RECALL CAMPAIGN BULLETIN

NTB15-005

VOLUNTARY SAFETY RECALL CAMPAIGN 2013-2014 PATHFINDER; SECONDARY HOOD LATCH

CAMPAIGN ID #: PC343
APPLIED VEHICLE: 2013- 2014 Pathfinder (R52)
2014 Pathfinder hybrid (R52)

Figure 3

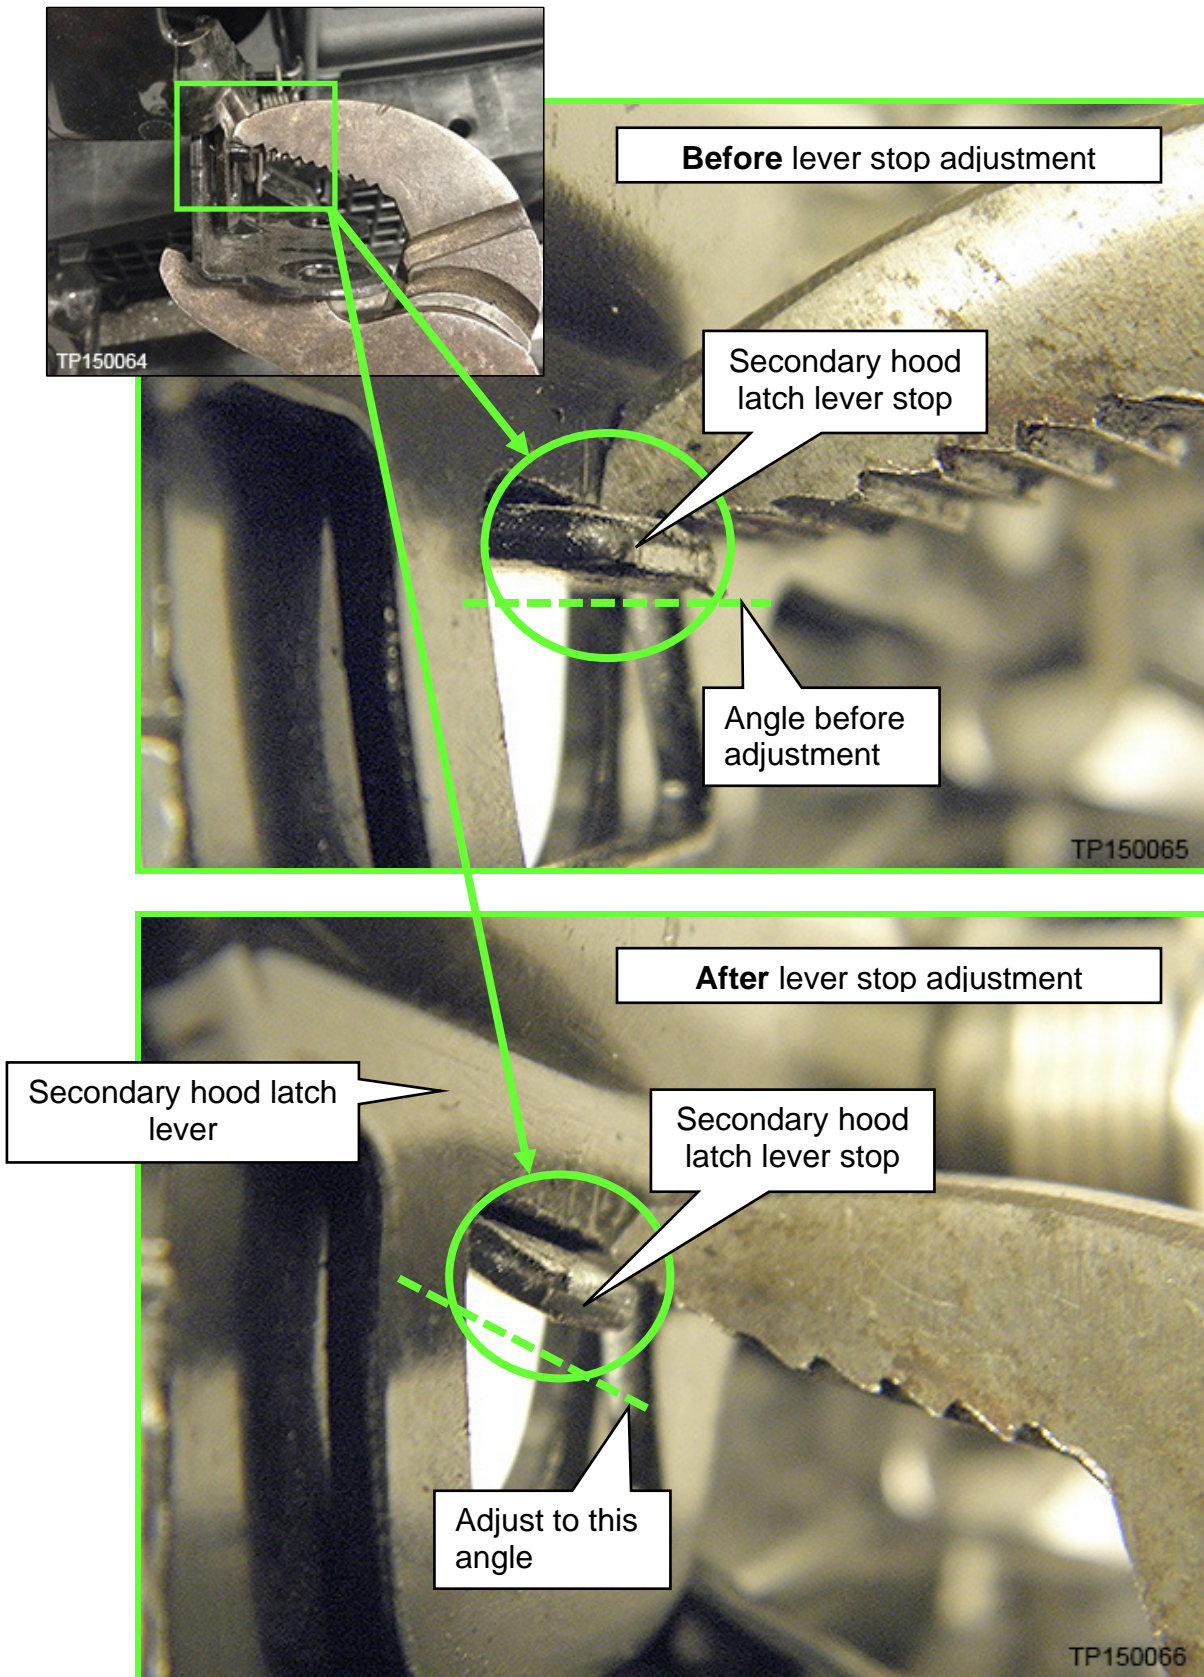
- Using a suitable tool, bend the “secondary hood latch lever stop” down (Figure 3) so that the bottom of the lever rests on the base of the hood lock assembly bracket (Figure 5, page 4).
